MAYFAIR REPLAT 6

RECOMMENDATION REPORT

CASE NUMBER: 2012-SUB-05

RE: Application for Replat-Initial Review
Mayfair 2nd Addition Replat Six (Replat of Lots 8A & 7B)

SARPY COUNTY
FINAL PLAT

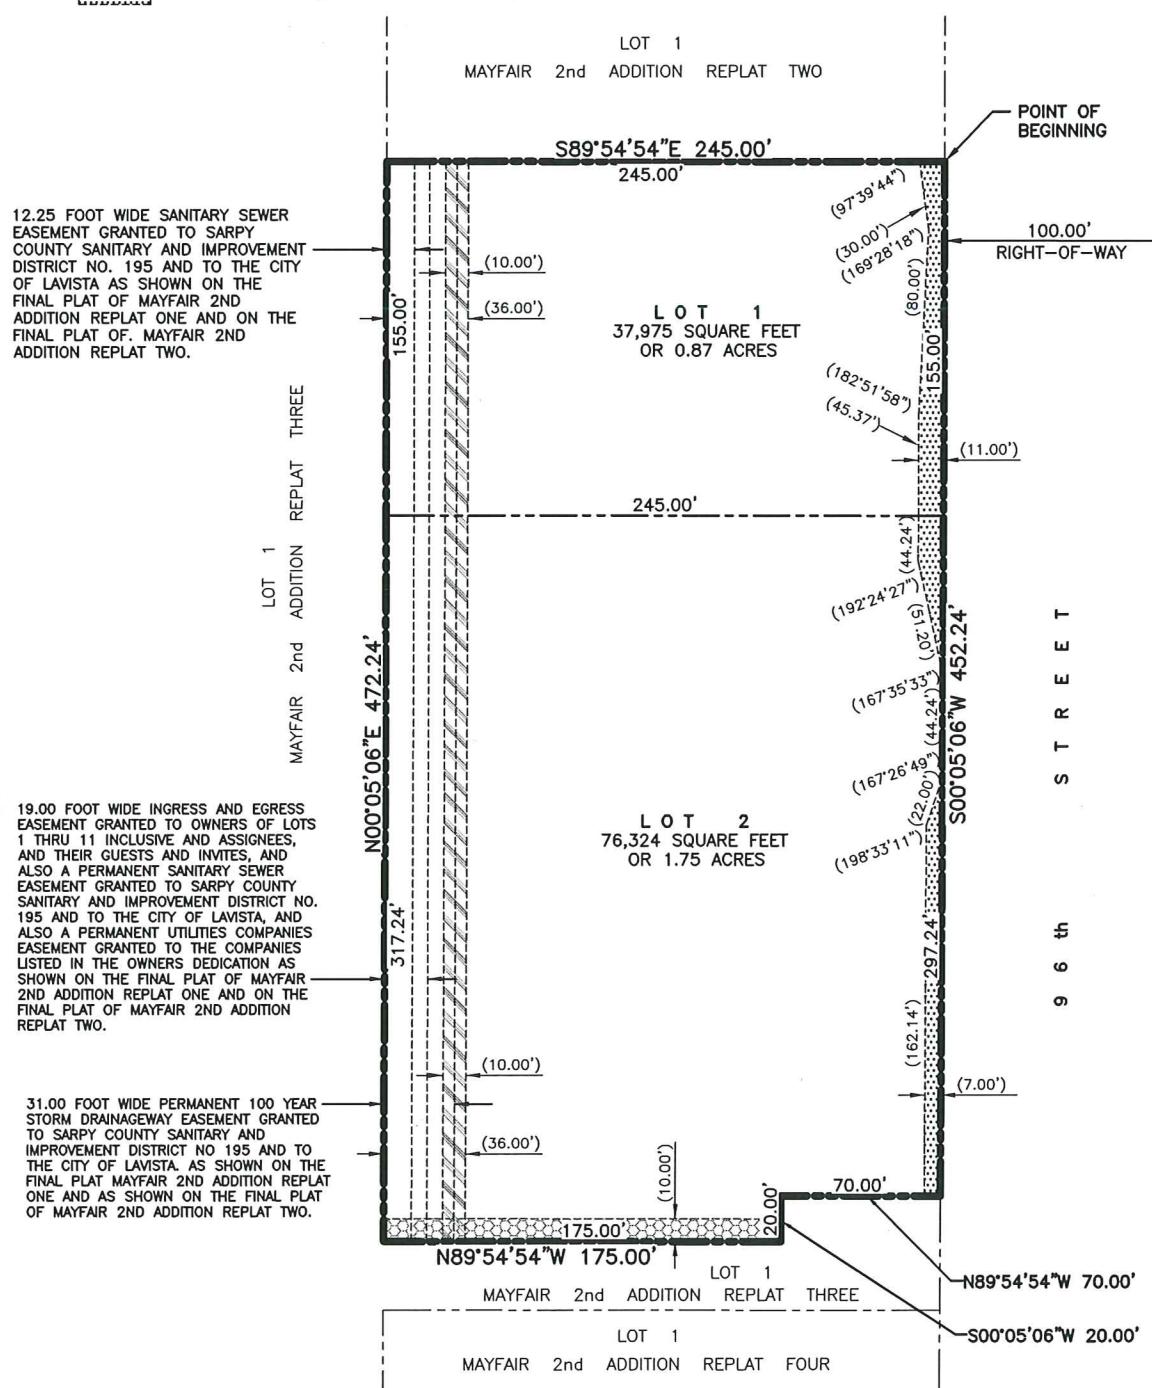
1. An easement document for the pedestrian sidewalk along 96th Street needs to be submitted, reviewed and ready to record prior to releasing the final plat for recording. It has been illustrated on the revised final plat with a notation that says "See Recorded Document", no document has been submitted at this time.
2. An easement for public usage of sidewalks to be constructed along the private roadways is to be provided.
3. The City will need to be provided documentation of the releases of utility easement rights along the previous interior lot line prior to releasing the final plat for recording.

8. The final plat was reviewed for compliance with Section 3.03 of the Subdivision Regulations. Comments from that review are as follows:
 - a. The name of the plat needs to be changed as noted above.
 - b. Releases from utility companies for easement rights along the original interior lot line location need to be provided prior to obtaining signed mylars from the City for recording.
